**PROJECT:** CWSRF WWTF IMPROVEMENTS  
WATER WORKS AND SEWER BOARD OF THE CITY OF DADEVILLE  
SRF PROJECT NO: CS010867-03  
GMC PROJECT NO: CMGM240012

**RE:** ADDENDUM #3

## ADDENDUM NUMBER 3

### CWSRF WWTF IMPROVEMENTS

**AERATION BASIN  
PLAN & SECTION**

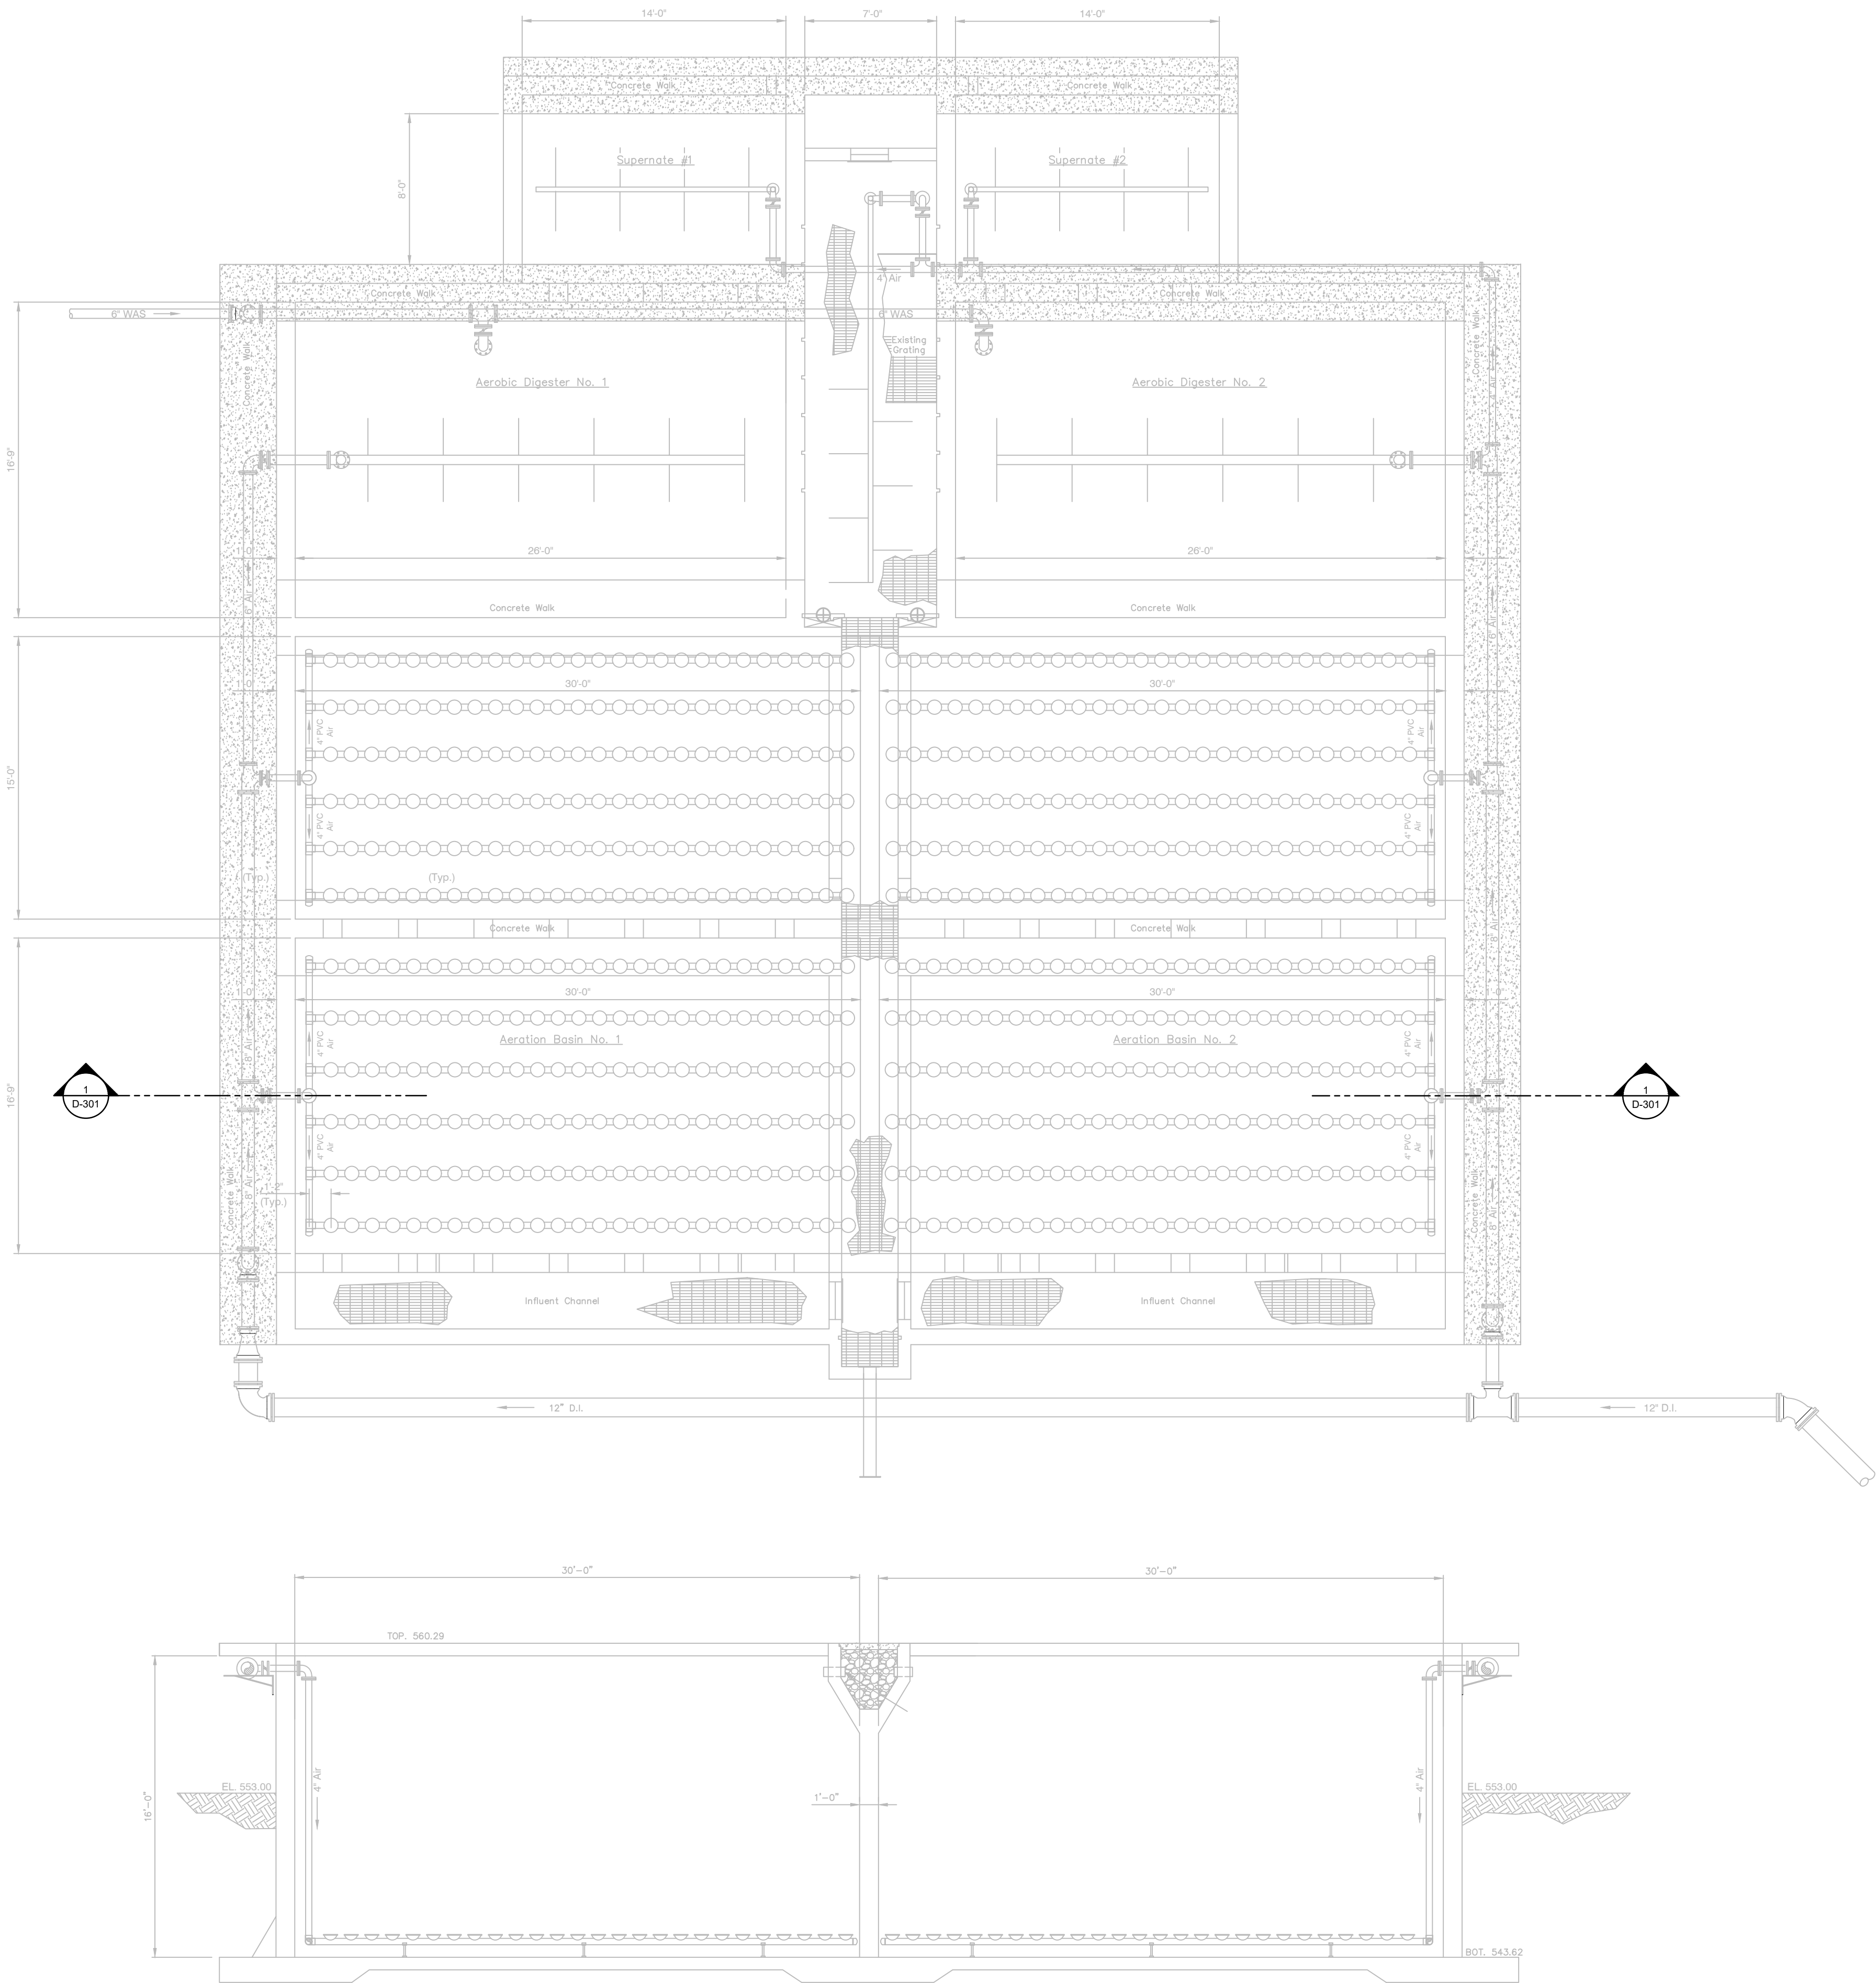
Answer: Specification 09 80 10 – Protective Lining for Concrete shall be used for coating of the concrete walls.
- 4.10 **Question: Is there a dimensional drawing available for the Aeration Basins and the Aerobic Digesters depicted on Drawing D-302 or do the bidders need to field measure these structures?**

Answer: Record drawings of the aeration basins and digesters are attached to this Addendum.
- 4.11 **Question: What is the thickness of the concrete wall indicated for partial demolition on X-701?**
